EPRI (2004, 2006) Ground-Motion Model (GMM) Review Project

**Responses to NRC Review Questions
and Comments Dated July 3, 2013**

July 30, 2013

Figure 7.3.3-1 Comparison of analytical and empirical amplification factors for 1 Hz. Results shown are based on data for $M \geq 4.75$ and $R_{JB} \leq 500$ km

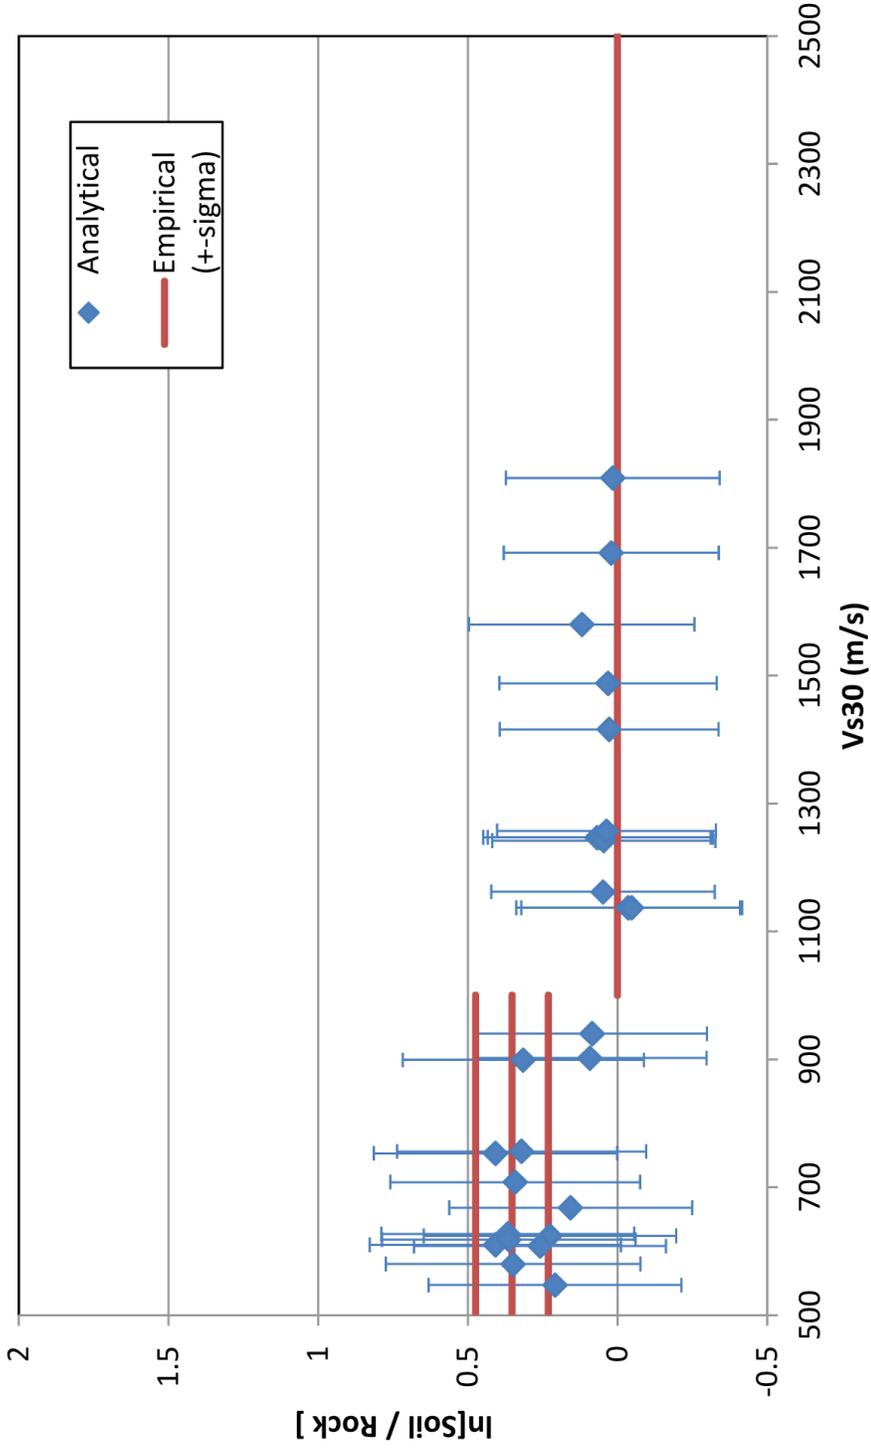
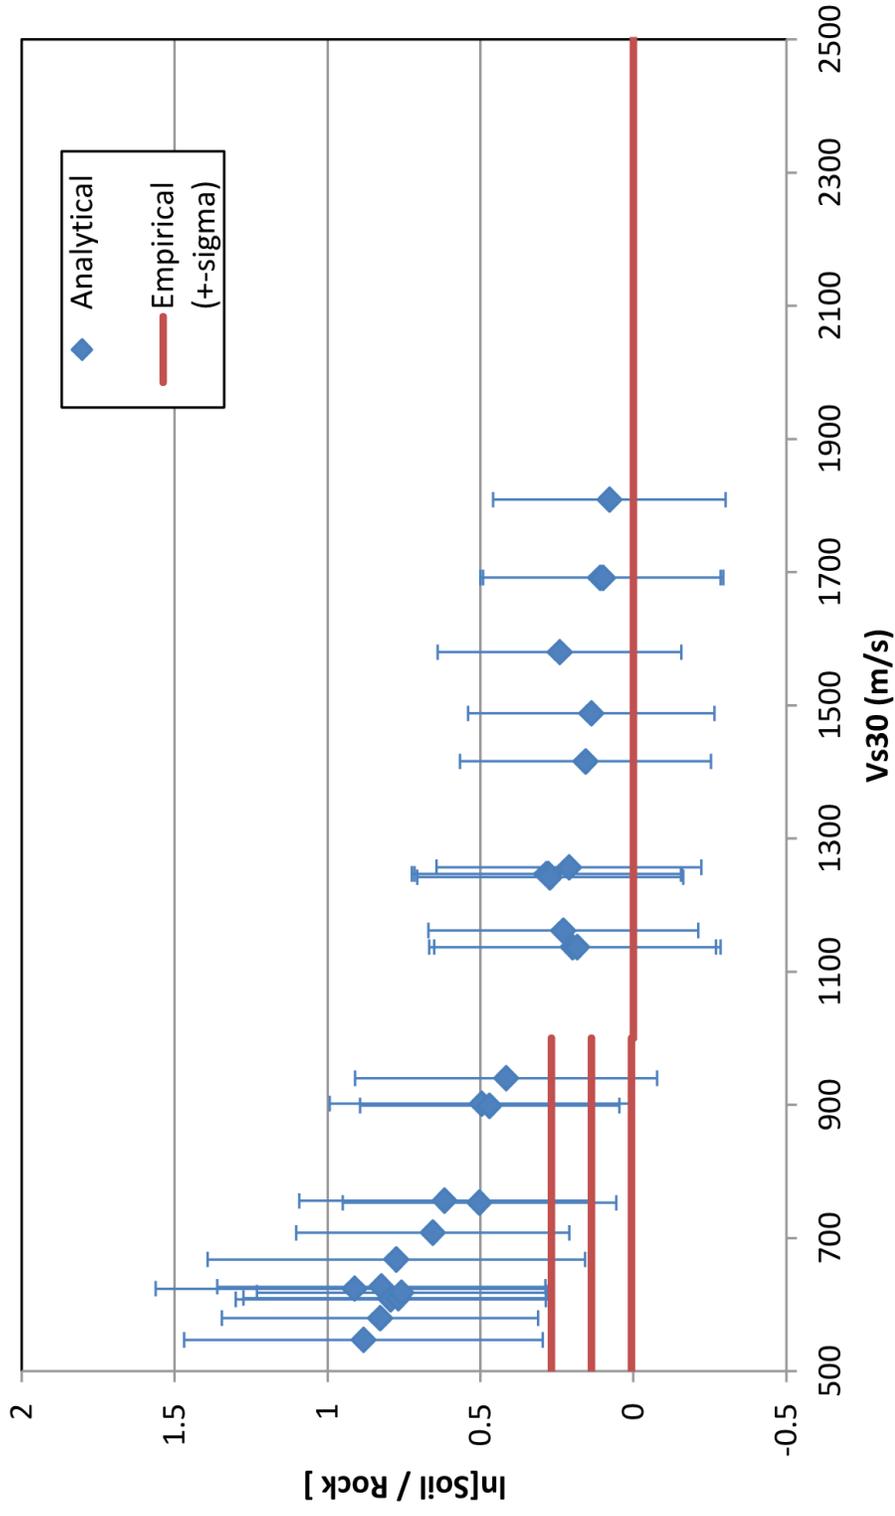
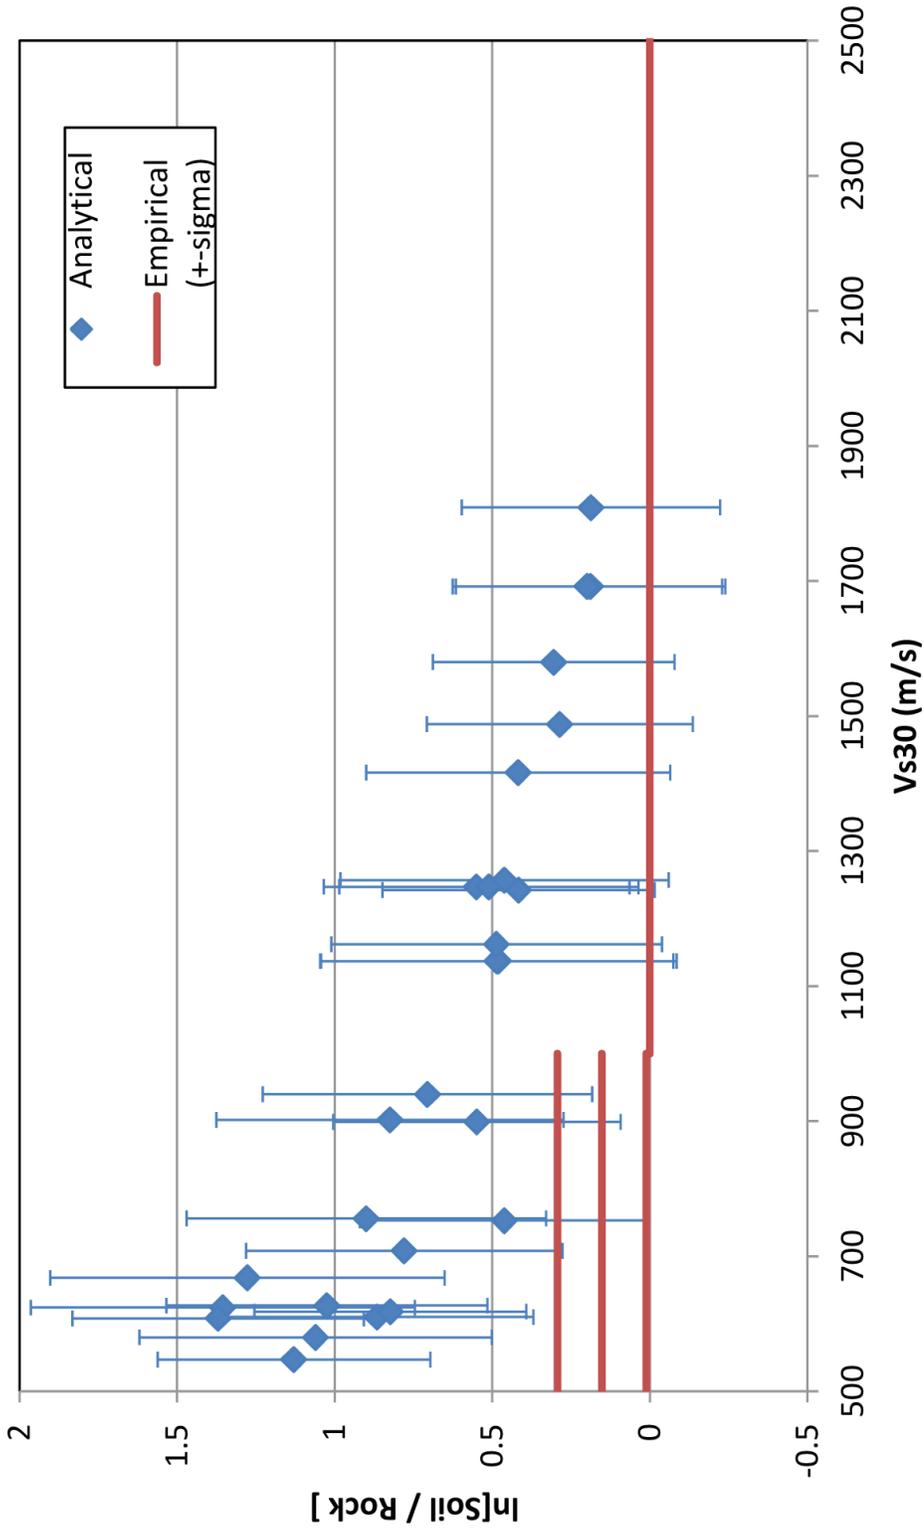
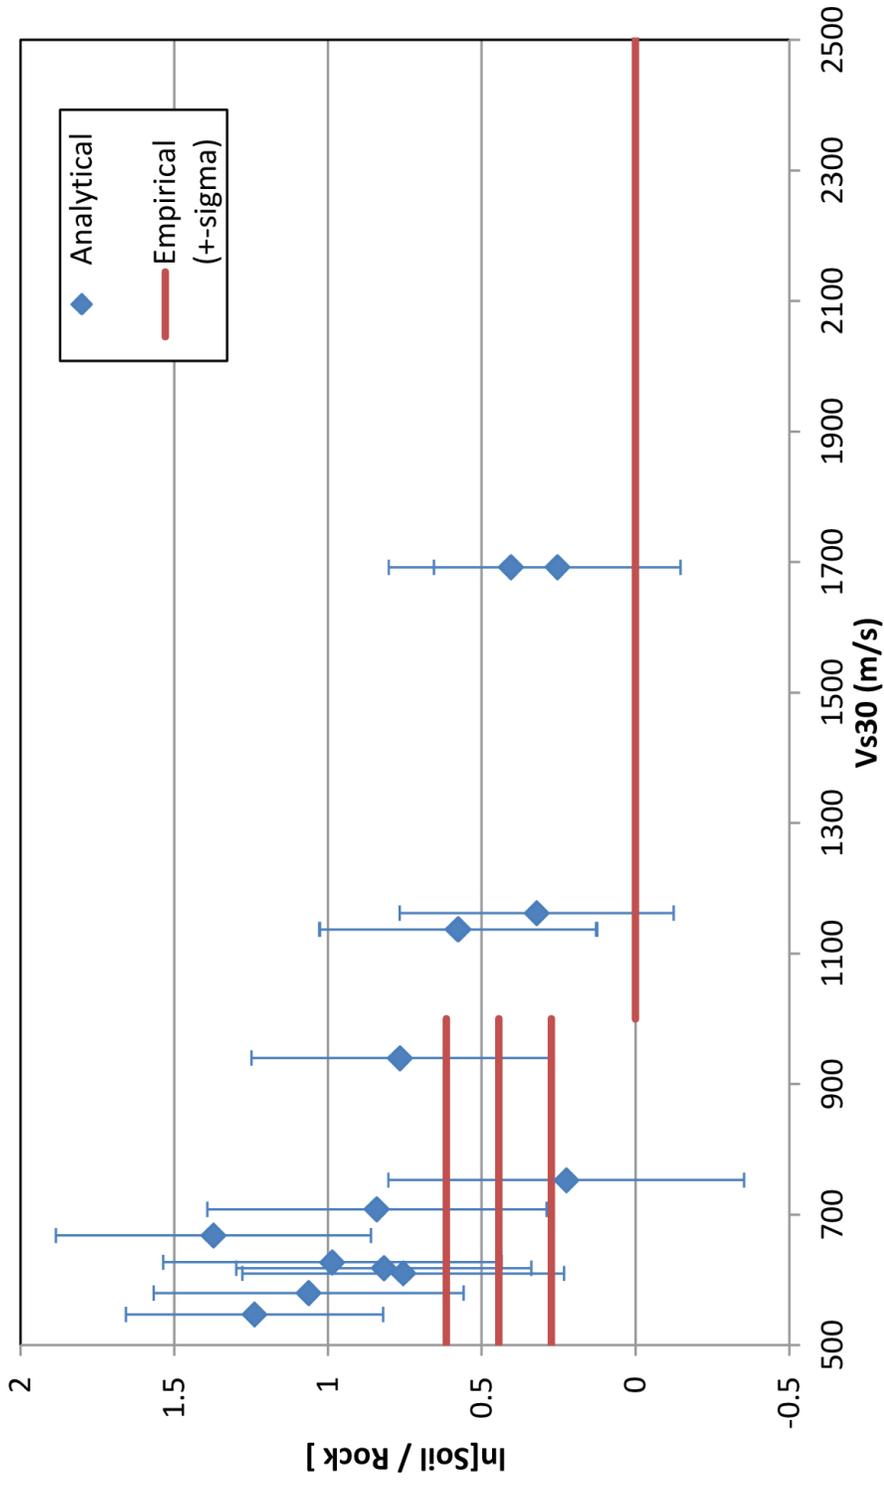
Question 3c: *In Section 7.3.3 of the report example amplification factors developed using the empirical and analytical methods are compared. It is not clear from the description provided in Section 7.3.3 how the empirical results shown in Figures 7.3.3-1 through -4 were developed. Please clarify how the empirical results were obtained. Specifically, clarify which of the three empirical Models was used how the residuals are computed (relative to EPRI 2004 or the update GMM).*

Response: The empirical results were obtained using Method 3 presented in Section 7.3.2 (i.e., Equations 7.3.2-3 and 7.3.2-4) and applied in Section 7.5.2 (see Equation 7.5.2-1 and Table 7.5.2-1). The median values shown for the empirical method (i.e., the middle horizontal lines) are the median values of C_{SR} over all GMPEs in Table 7.5.2-1. The empirical + sigma range includes both the standard error in C_{SR} and the model-to-model differences in C_{SR} (see Table 7.5.2-1 for both).

Figure 7.3.3-5
 NGA amplification factors for magnitude 6 at 100 km. Modified from Abrahamson et al. (2008)

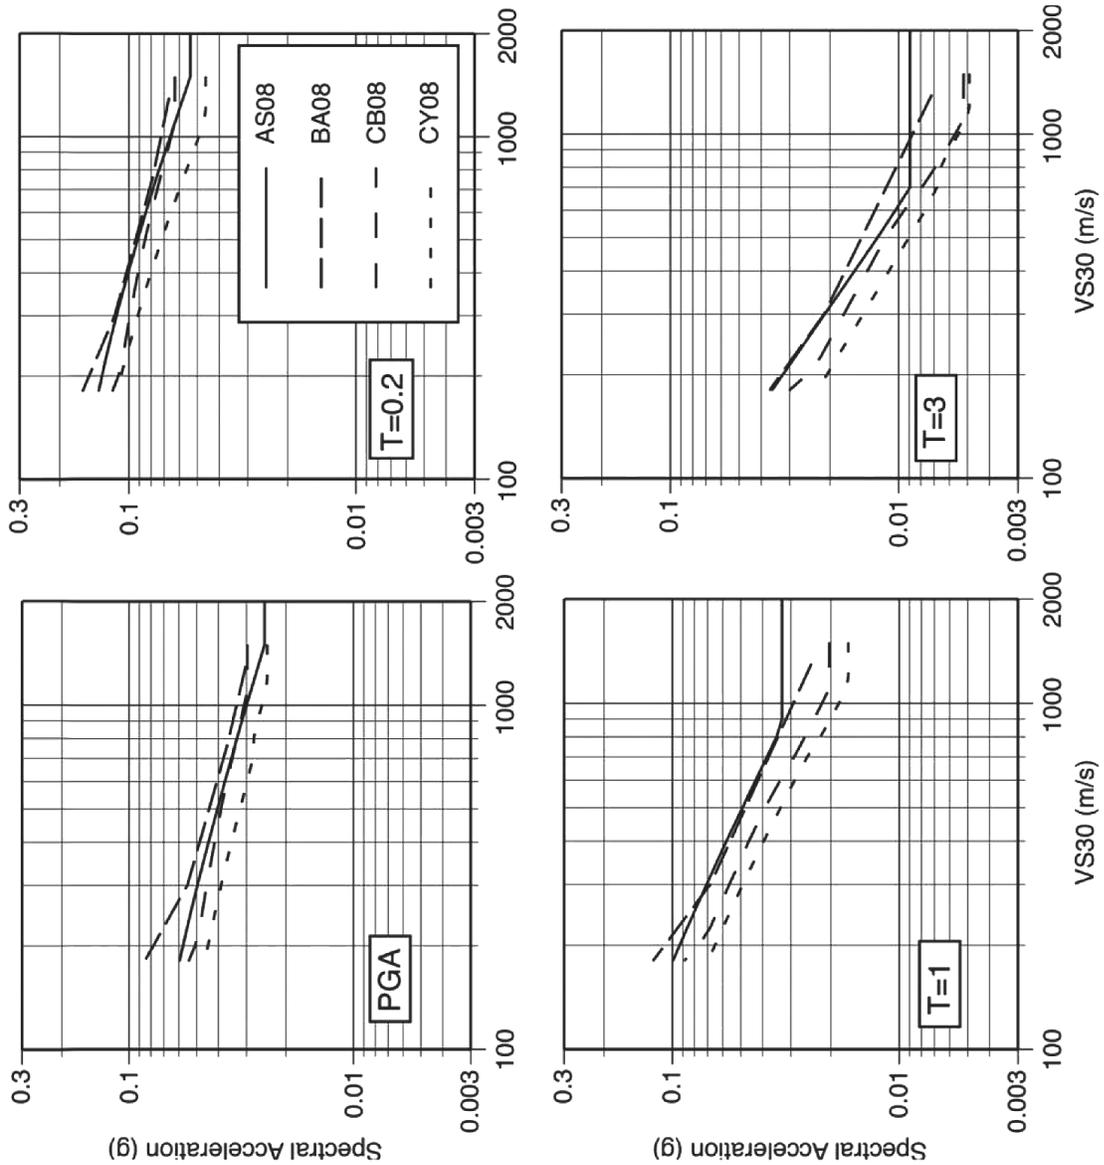
Question 3d: *In the last paragraph of Section 7.3.3, reference is made to Figure 7.3.3-5 which is from the NGA summary report of Abrahamson et al. (2008). The text indicates that the figure illustrates consistency with the proposed EPRI (2013) amplification factors. Provide clarification on whether the cited figure is the appropriate figure and supports the conclusions in the text.*

Response: Figure 7.3.3-5 is the appropriate figure. Figure 7.3.3-5 shows a monotonic decrease in amplification factors with increasing V_{S30} , which is the same pattern shown by the analytical and empirical amplification factors in Figures 7.3.3-1 through 7.3.3-4 (i.e., amplification factors of 1.6 to 2 between V_{S30} values of 500 and 1,500 m/s). The empirical and NGA amplification factors saturate at 1,500 m/s, and we interpret this saturation as a consequence of not having sufficient recordings from hard-rock sites.
